G&E7004/8/11 CONVECTION OVEN G&E7204/8/11 CONVECTION OVEN

DOOR SEAL FIXING METHOD

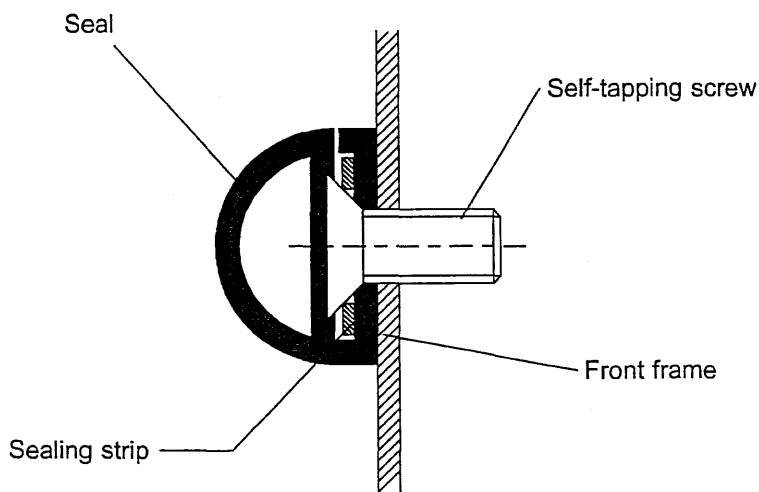
Due to supply difficulties, the clips which secure door seal to oven front frame are no longer available.

The preferred method of fixing seal is by using countersunk, self tapping screws.

The metallic sealing strips will still be used. Insert the screws through holes in sealing strips and the seal.

Screw fixings into the front frame holes that were used for spring clips.
